From: [Eli Z Tsarovsky](#)
To: [Plan Commission Comments](#)
Subject: Plan Commission - 12.12.22 - Agenda Items 6-8
Date: Monday, December 12, 2022 9:27:37 AM
Attachments: [Lake Street Garage Committee Report \(1\).pdf](#)

My name is Eli Tsarovsky and I am the President of the Campus Area Neighborhood Association. I am emailing you all today in opposition to the current plans for the 415 N Lake Street Redevelopment in the 2nd Ald. Dist.

Lake Street Garage Steering Committee Report

November 21st, 2022

Alternate Layout

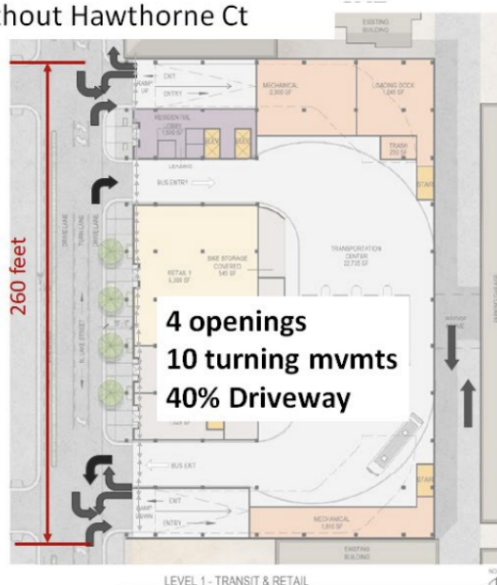
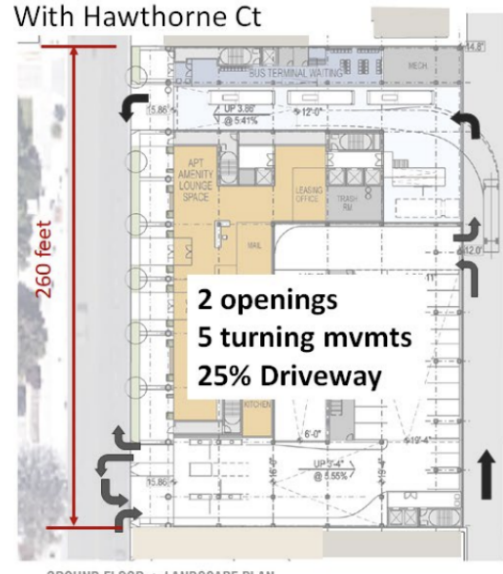
Residents provide feedback on the bus terminal that covered topics of rider amenities and bus parking. People were concerned about the opening to Hawthorne that could be used by people as a cut-through to bars during gamedays and other events. There were no clear amenities described for riders and how the bus terminal would be managed. The development team should anticipate parents and children using the terminal and consider how the project will provide adequate safety measures and security for riders. There are families that use the bus and having kids around so much traffic presents a safety issue. Also, having the bus terminal open on Hawthorne Ct invites drunk people to cross here on their way from bars and does not provide a good experience for people waiting for the bus. This is problematic for pedestrian traffic of riders going to and from the bus terminal. The steering did not enjoy the transparency of understanding why this site was chosen for the bus terminal and what other locations were studied.

The traffic flow of the current proposal requires intercity buses to cross important, busy lanes of traffic that include **the Major BRT (Bus Rapid Transit) Lane, the unprotected Bike Lane, and the Major Sidewalk**. This is a major logistical flaw as this presents lots of opportunities for major backups on University Ave due to buses not being able to cross the lanes of traffic and a higher risk of accidents due to the Hawthorne Ct functioning as an alleyway and not being a controlled intersection. Not to mention University Ave is a much faster street than Lake Street and increases the risk of accidents like fender benders and bikers being hit during rush hour traffic. The development needs to use Lake Street for buses because it is a controlled intersection with a stoplight as compared to the Hawthorne Ct entrance which has no traffic signals. Additionally, the East Campus Mall BRT Spot can be inferred as a major bus stop for students commuting across campus. The three major residence halls are within a couple of blocks of this spot. Blockages at the Hawthorne Ct entrance will disrupt this major BRT system hub.

The three spots for buses seem inadequate and are shortchanging the intercity bus station potential. The bus terminal ought to have five bays like the old bus terminal and there needs to be a better plan for staging. They are trying to do too much at once and seem to be modeled after La Crosse without consideration of the unique challenges of this area. The Bus terminal is different and you can drive straight through it. This design

seems too complex at the moment. The proposal does not seem to completely address everything. The entrances for residential parking are on the same side as the Van Galder Bus entrance. This mix of traffic seems problematic with bus schedules and the residential experience. If there is a queue that wraps around the corner, this will affect the BRT lane and Metro Bus lane. There is also a need for more entrances and exits to accommodate queues during special events.

- Moving the entrances to the bus terminal and parking to Lake Street
- Creating a Transportation plan that considers all modes of transportation on the site
- Using this project to activate Hawthorne Court with public art, lighting, and cameras
- Make the bus terminal part of a covered part of Lake Street.
- We need a complete Traffic/Environmental Study that considers the impact on local businesses, existing apartments, and all current modes of traffic circulating through this site.
